ADDENDUM NO. 08

February 12, 2010

Project: **Package C – 2009: Holbrook Elementary School Renovations**
 Cypress-Fairbanks Independent School District

Bay Project No.: 0840 (10-01-2069R-FP)

ADD8-SKE-01

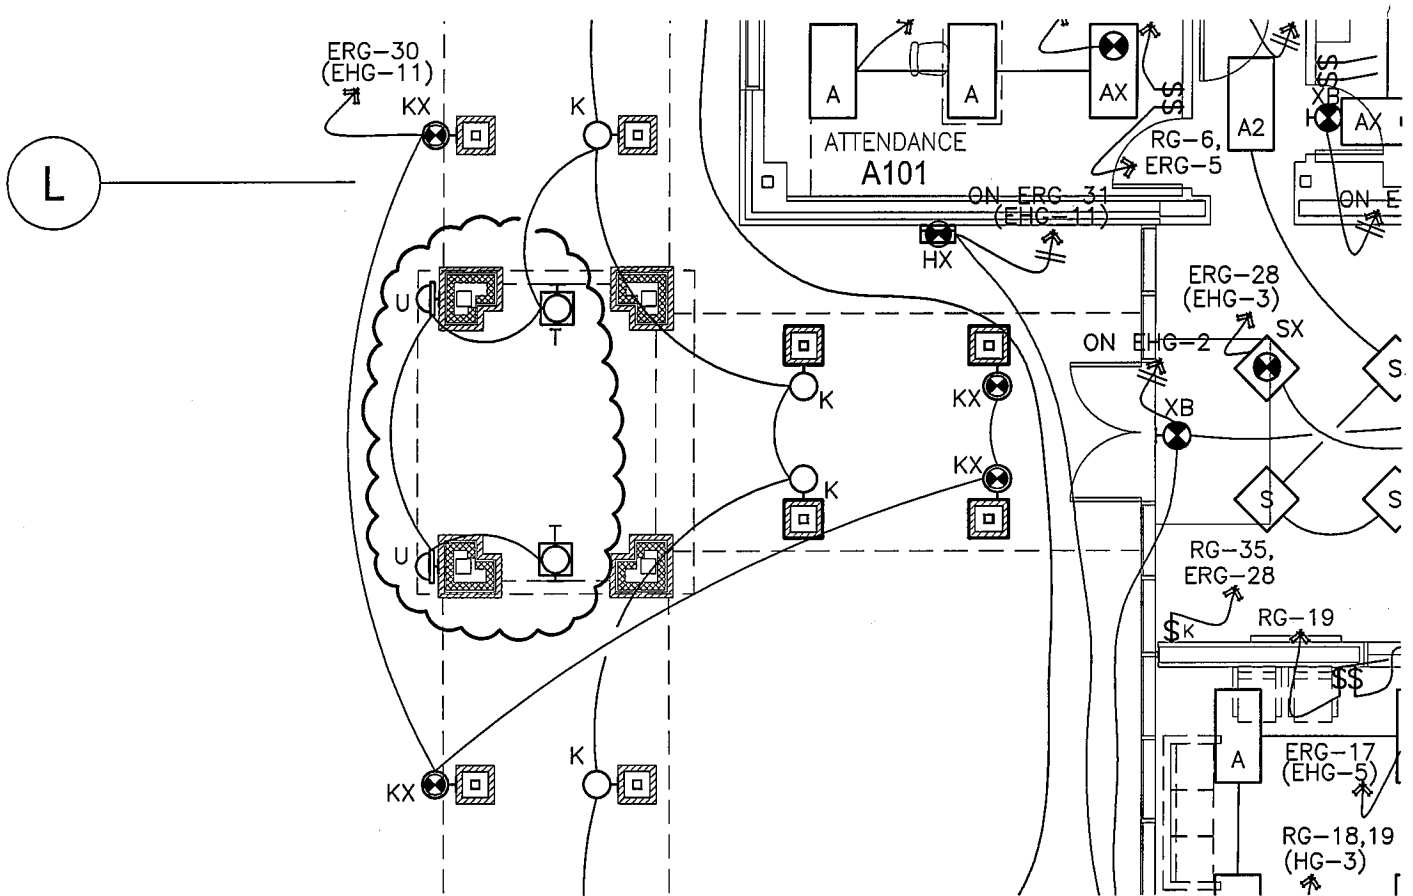
- c. Add two Type U light fixtures to columns outside main entrance to Lobby A100. Also add two type T light fixtures and connect all four additional fixtures to relay RG-36 on 277V circuit HG-13. See attached Drawing ADD8-SKE-01.

- c. Add Light Fixture Types T and U to Light Fixture Schedule. See attached Drawing ADD8-SKE-01.
19. Sheet P2.1 – Plumbing Floor Plan – Area B
- a. Pre-K B201: Revise classroom sink type to type “SK-6”.

ADD8-SKE-02

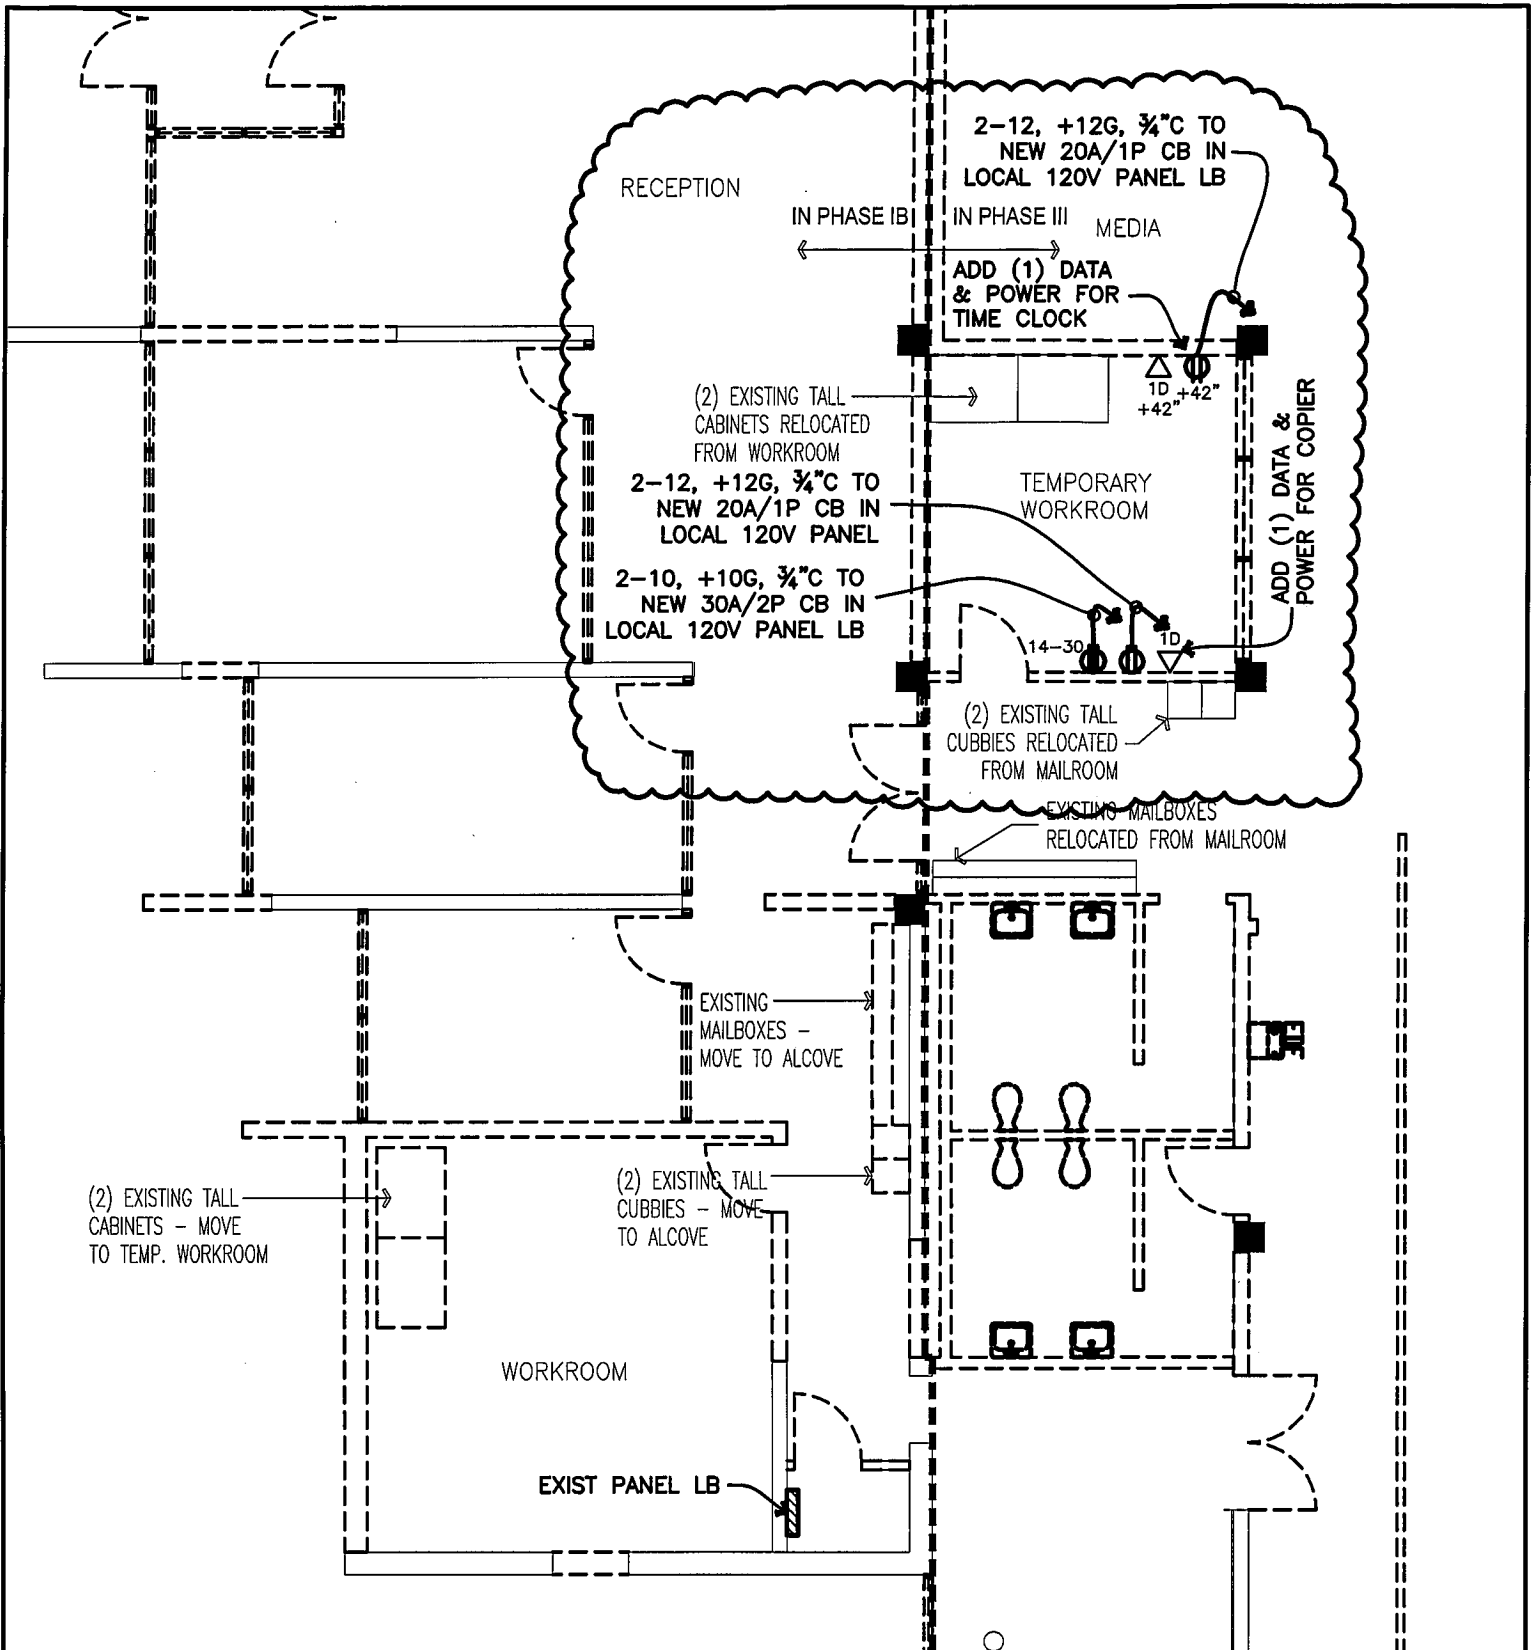
- a. Temp Workroom: Add electrical and data outlets. See Attached Drawing ADD8-SKE-02.
 - b. Temp Reception D608: Add (1) one phone outlet on south wall. See Attached Drawing ADD8-SKE-03.

ADD8-SKPI
 0840/0832
 SCALE: 1/8" = 1'-0"
 2/12/2010

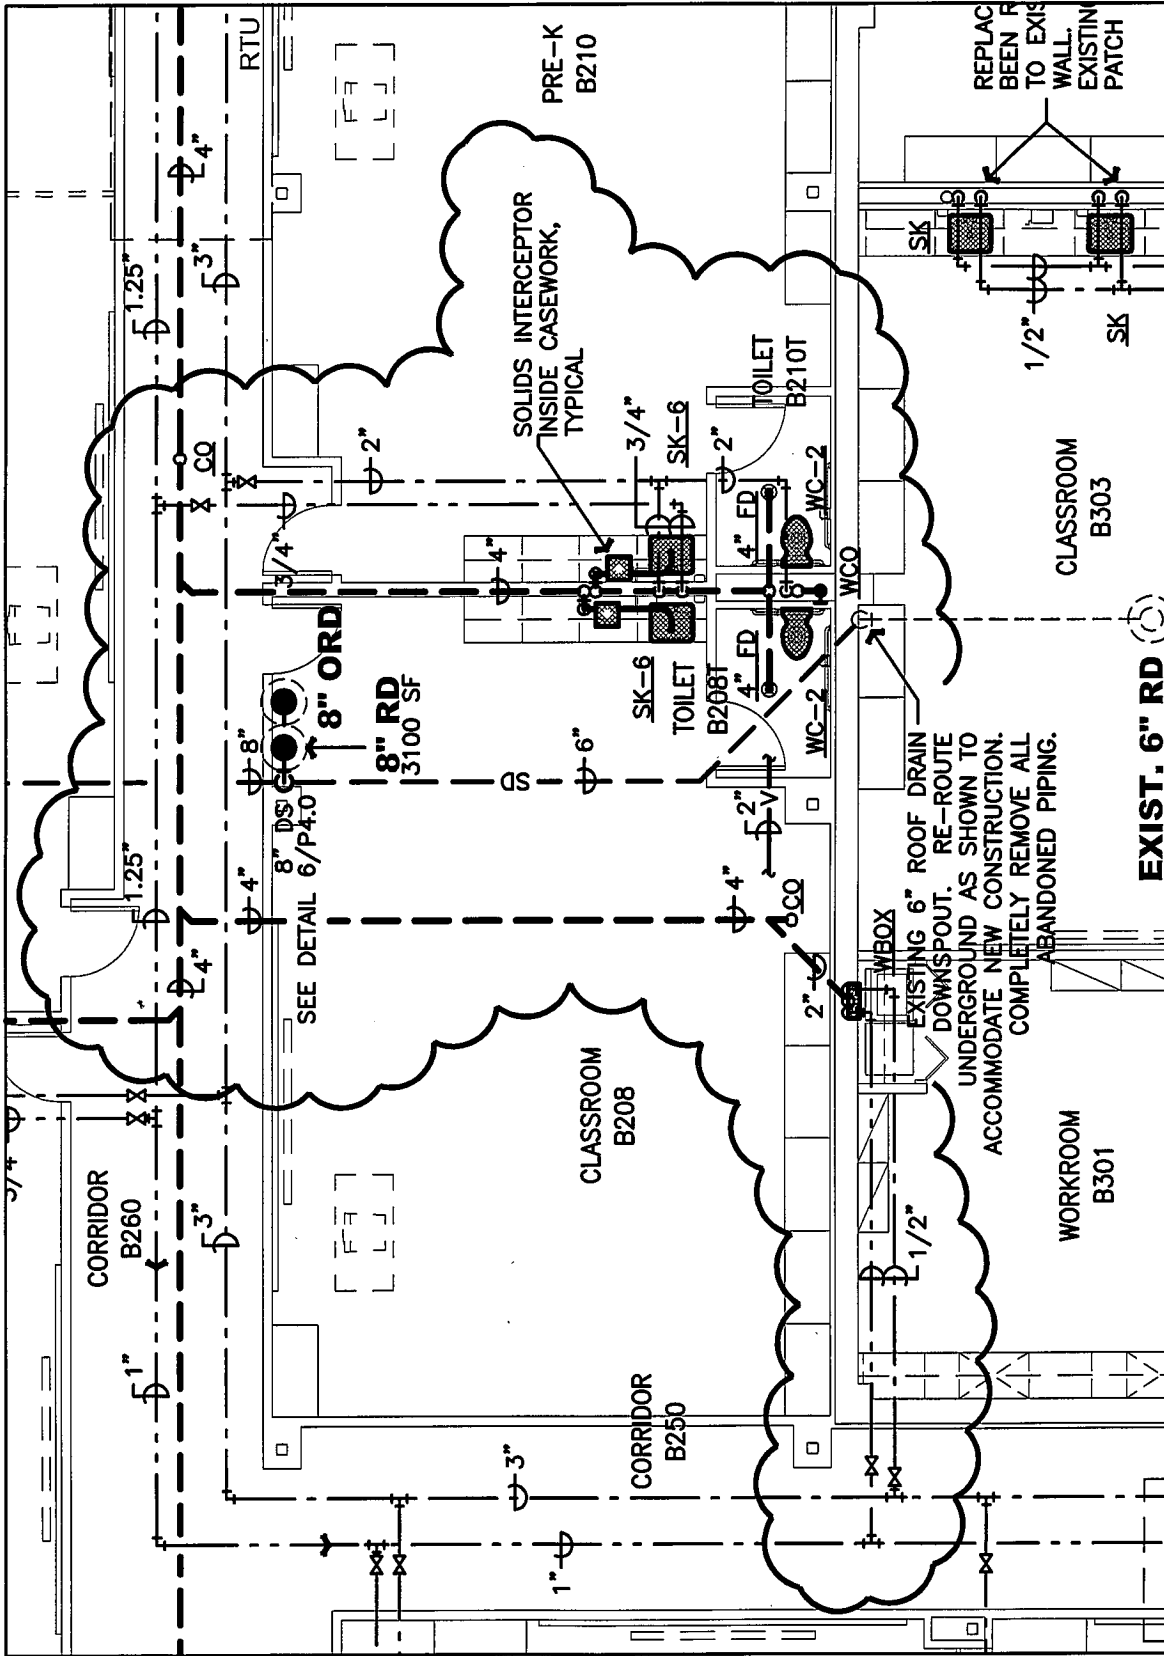
- h. Pre-K B212: Revise classroom sink type to type “SK-6”.
 - i. Science B213: Revise both (2) classroom sinks in this room to type “SK-6”.
 - j. Workroom B301: Add clothes washer drain/valve box (WBOX) for new clothes washing machine per Drawing ADD8-SKP1.

- a. Area B Risers: There are ten (10) classroom sinks “SK” that need to be revised to type “SK-6” with solids interceptor as described in addendum above.
- b. Riser P/B2: Add clothes washer box (WBOX), 2” waste/vent and ½” CW/HW, as described in addendum above.

AD8-SKP2

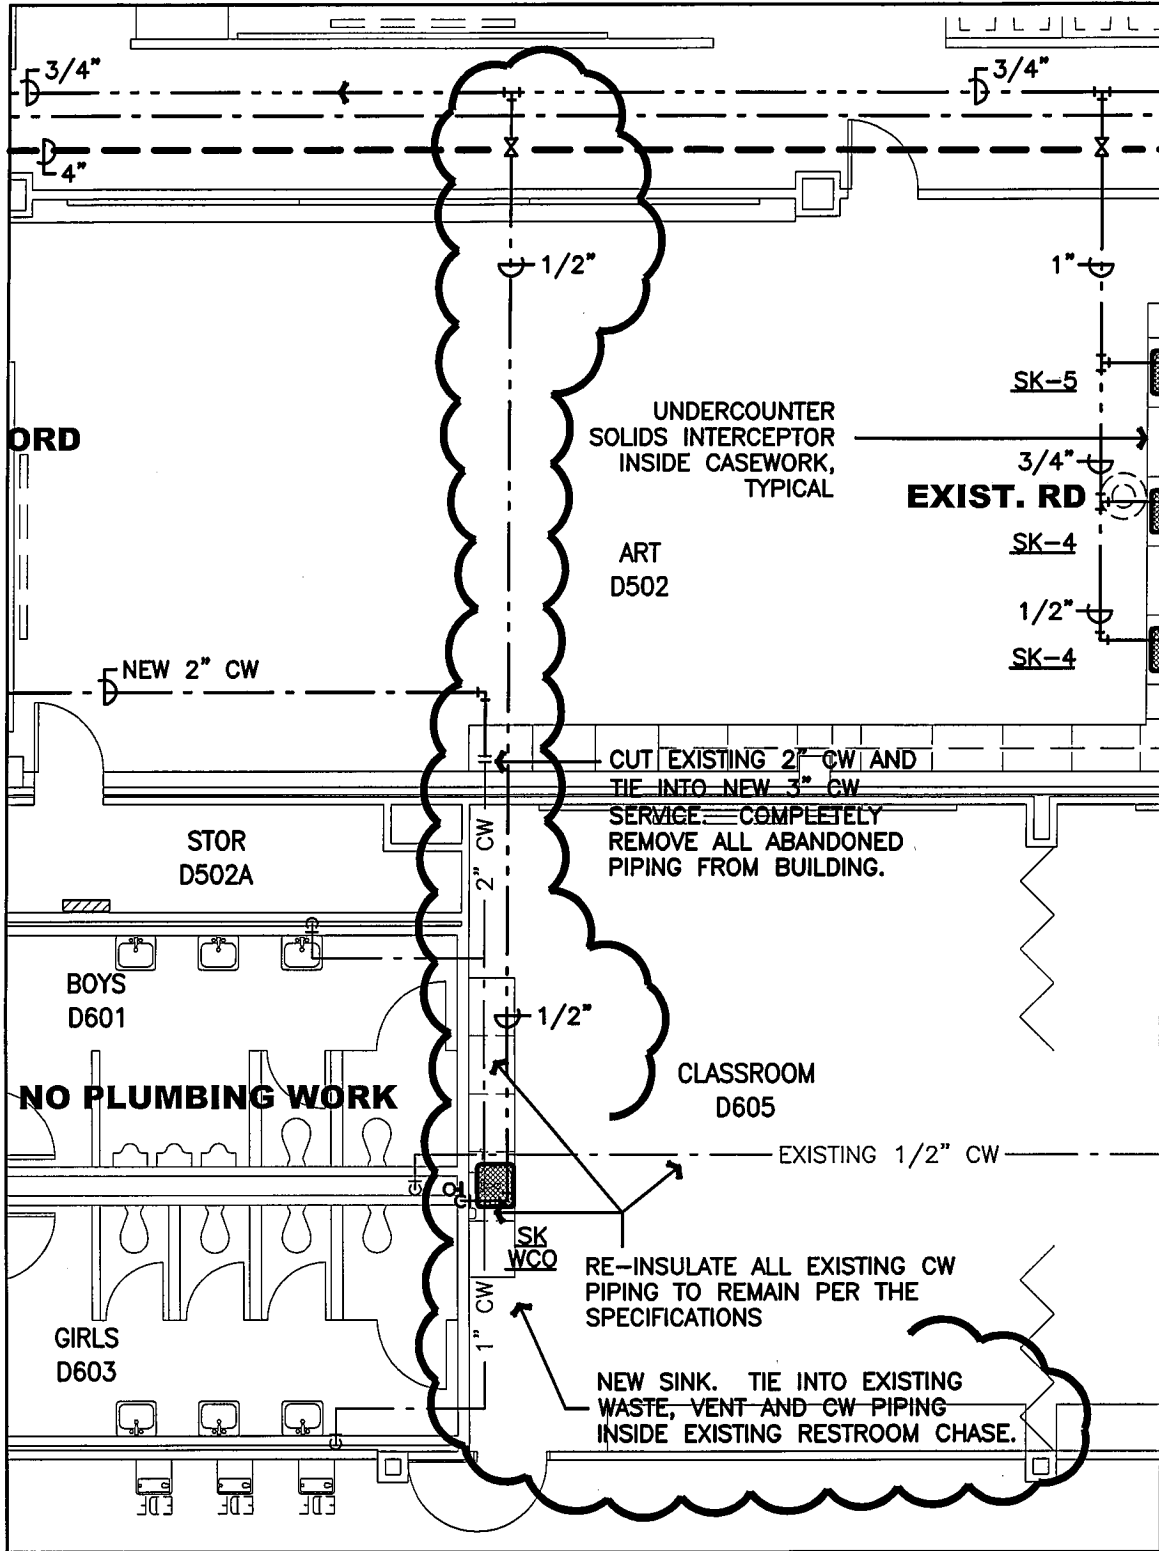
20. Sheet P2.3 – Plumbing Floor Plan – Areas D & E
- a. Classroom D605: Add new classroom sink “SK” in new casework per attached Drawing ADD8-SKP2.
 - b. Classroom D611: Add new classroom sink “SK” in new casework per attached Drawing ADD8-SKP3.

ADD8-SKP4
 0840/0832
 SCALE: 1/4" = 1'-0"
 2/12/2010

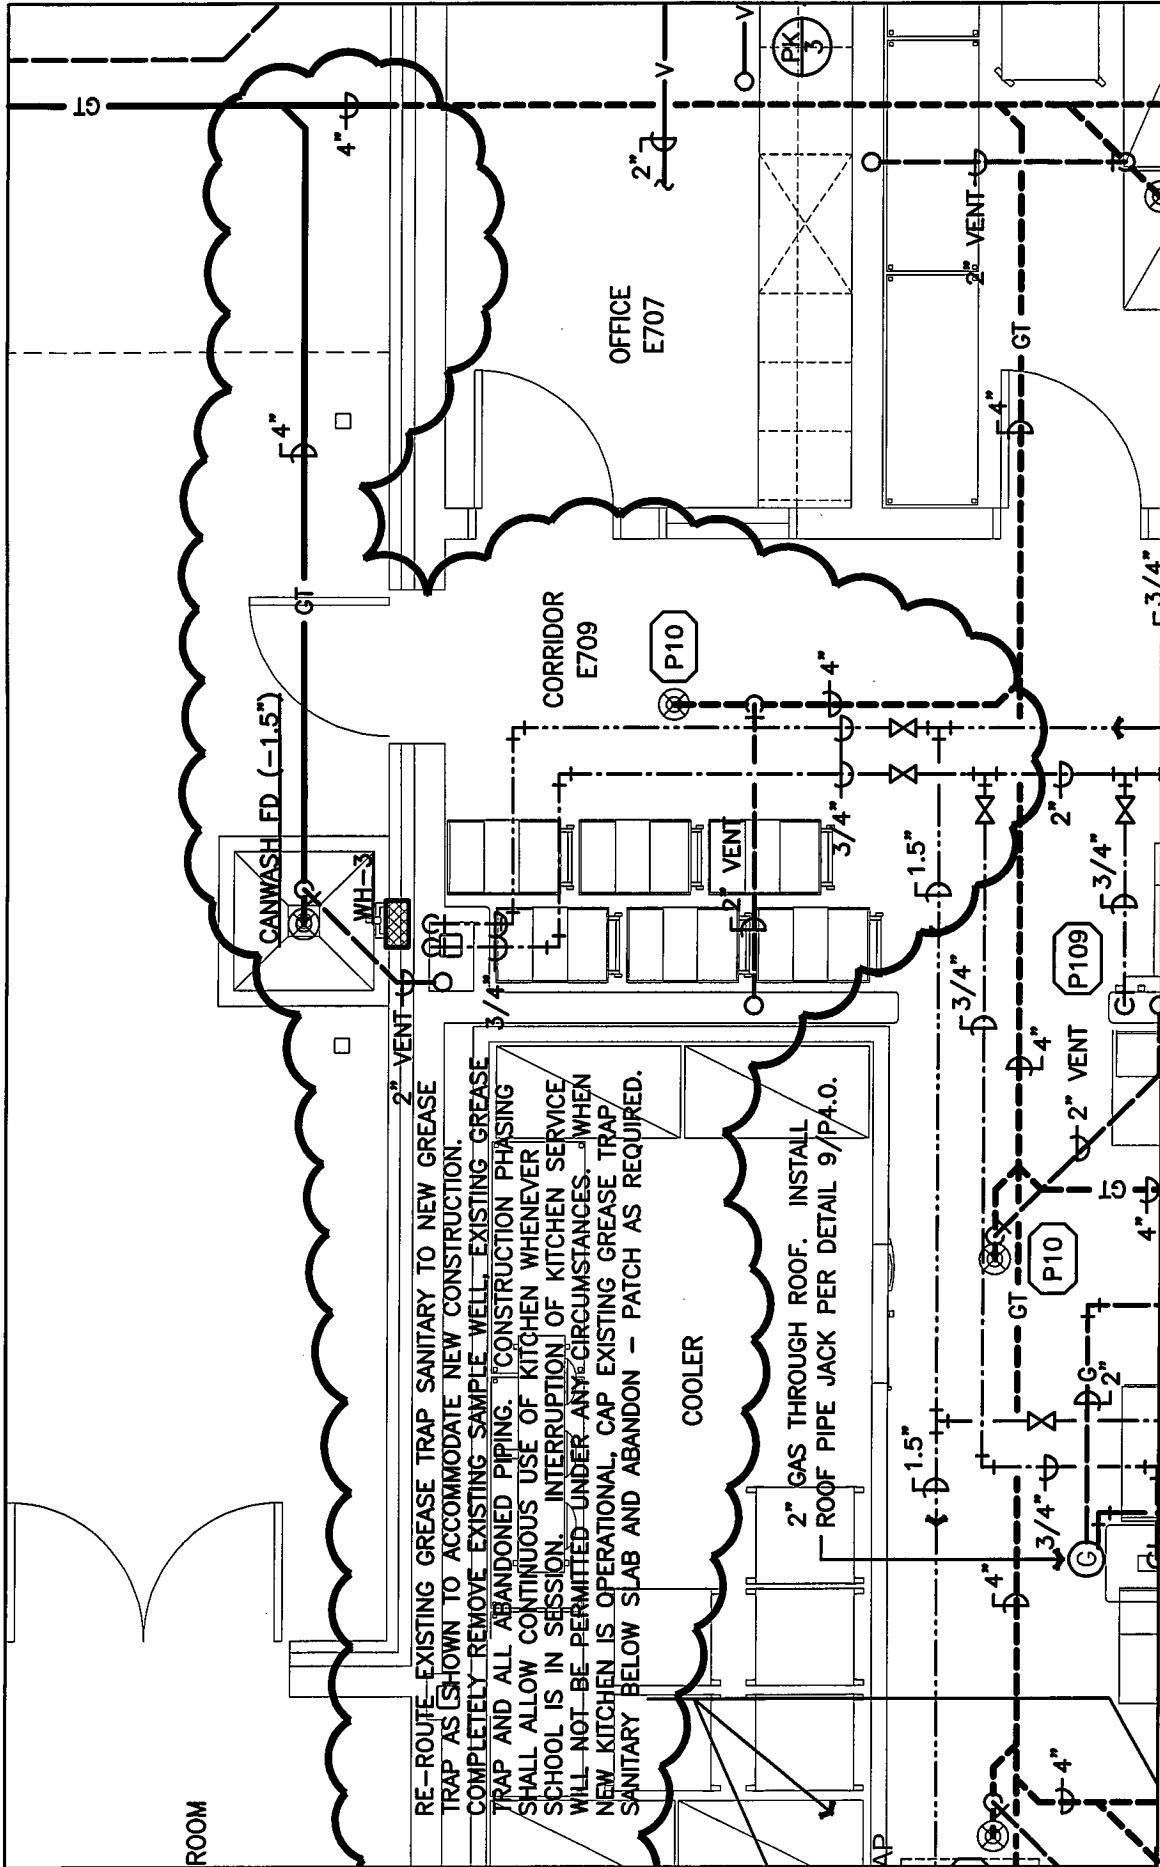
21. Sheet P3.0 – ¼” Scale Plumbing Plan Kitchen Area
- a. Add Canwash Hydrant (WH-3) and Canwash drain (CANWASH FD) outside exterior door per attached Drawing ADD8-SKP4.

- a. Riser PK/3: Add canwash drain and hydrant (CANWASH FD, WH-3), 4” waste and 2” vent and ¾” CW/HW, as described in addendum above.
